ADDENDUM NO. 3

**MLK ELEMENTARY SCHOOL
TRANSITIONAL KINDERGARTEN
BAKERSFIELD CITY SCHOOL DISTRICT**

**Project No.: 5593
DSA File No. 15-6
DSA App No. 03-123900
January 24 2025**

Sheet No.: **S2.02**

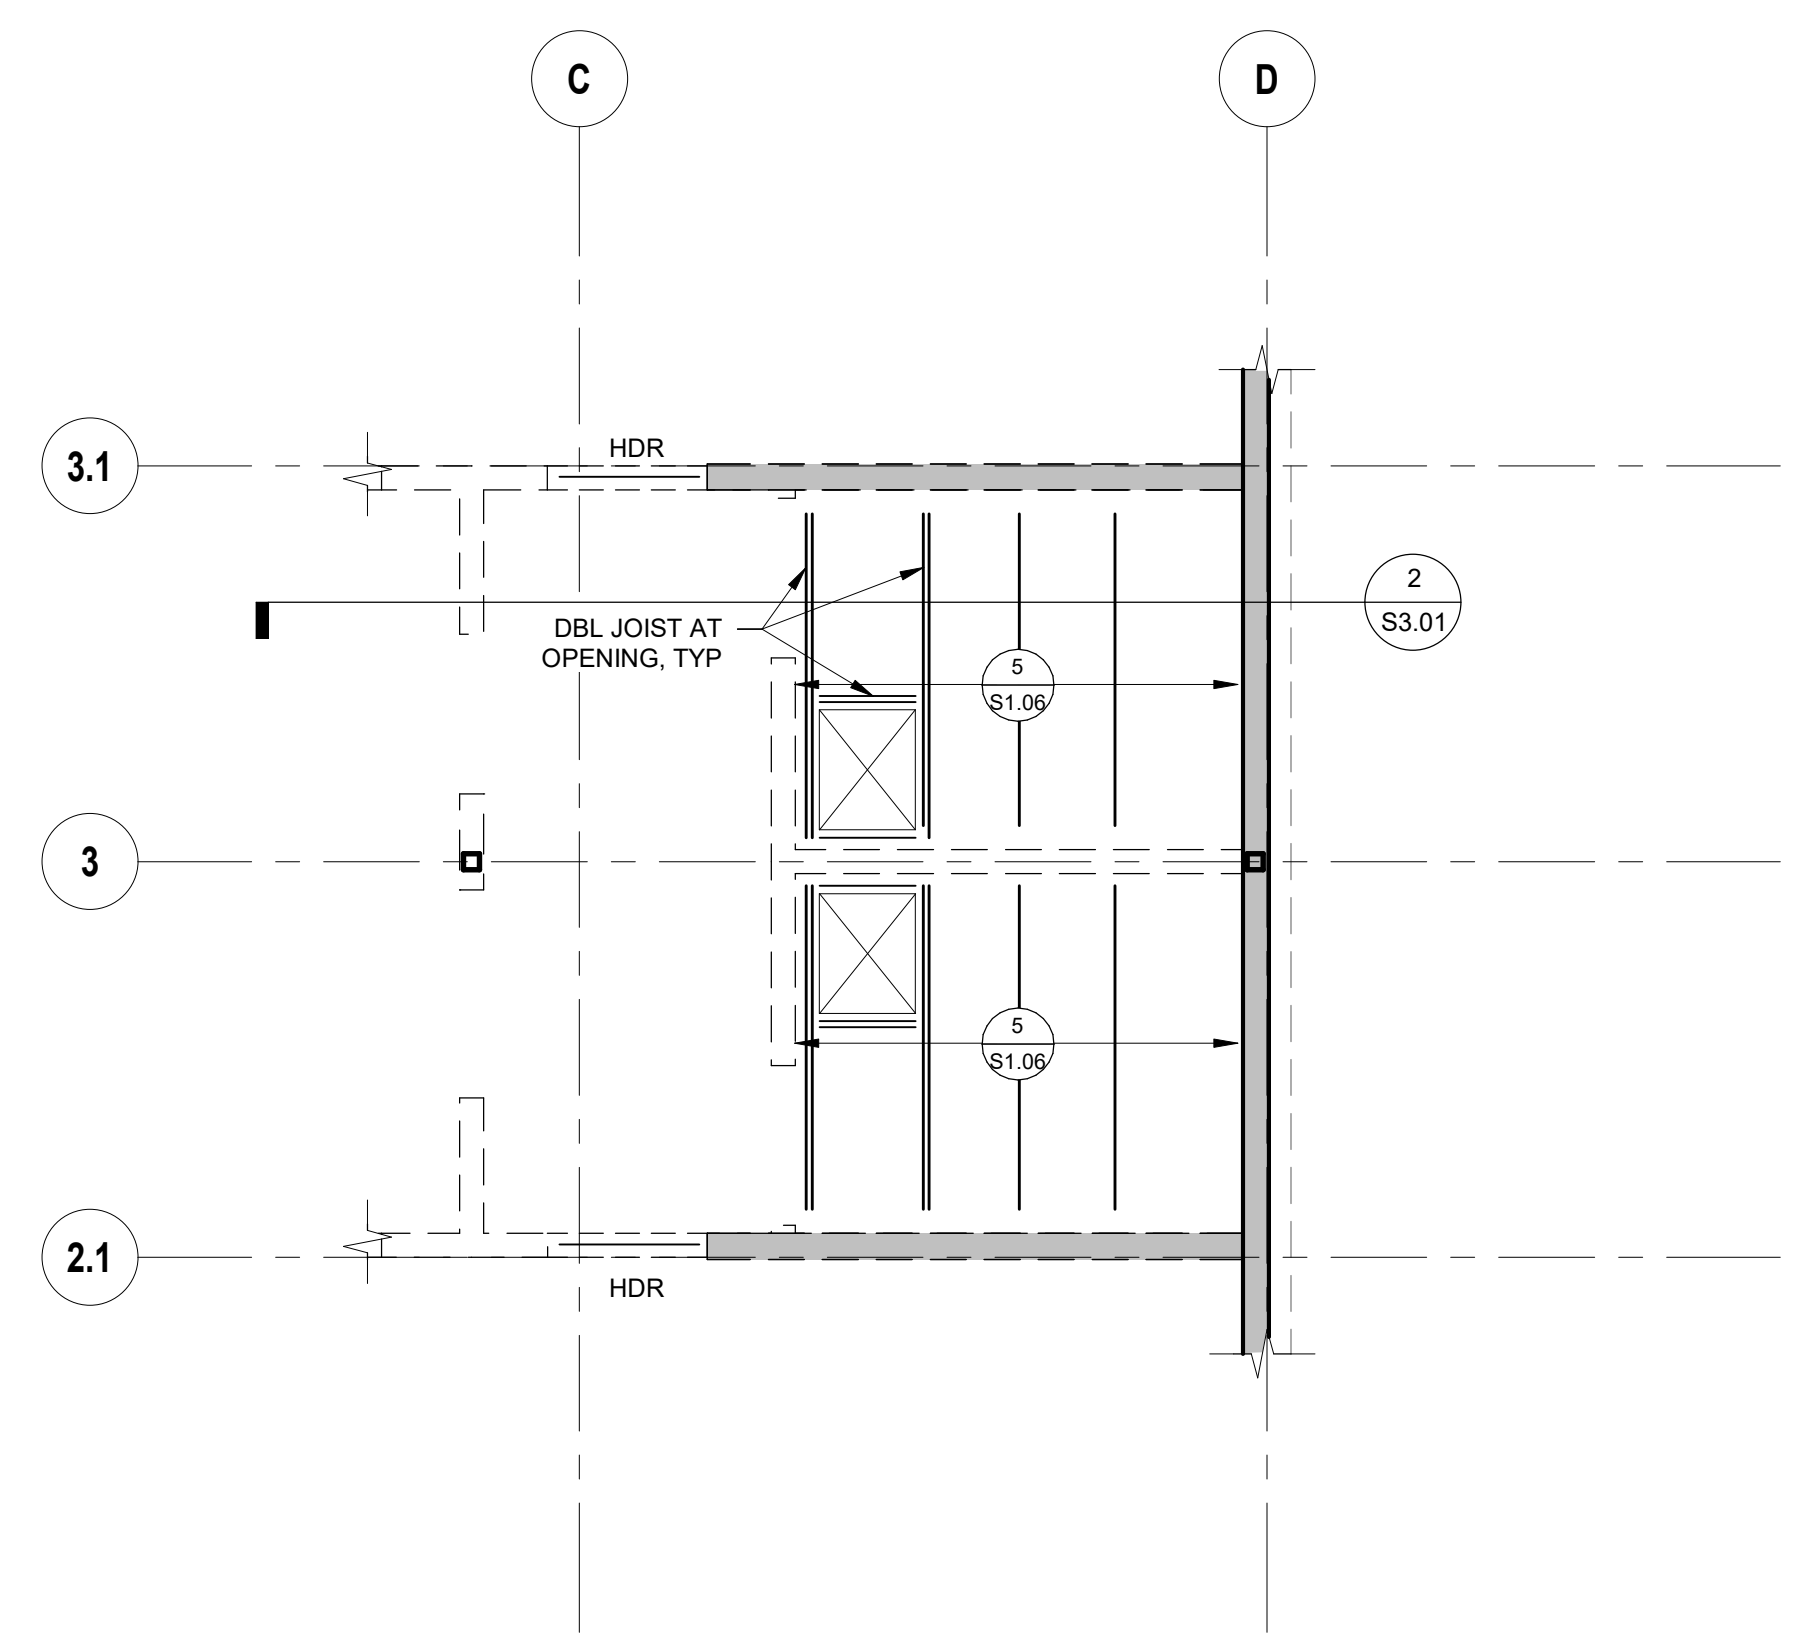
3-22 DRAWING, SHEET S2.02 – ROOF FRAMING: The HSS beam along grid line 1 and 5 are to be AESS2. See exhibit S0.02 and S2.02
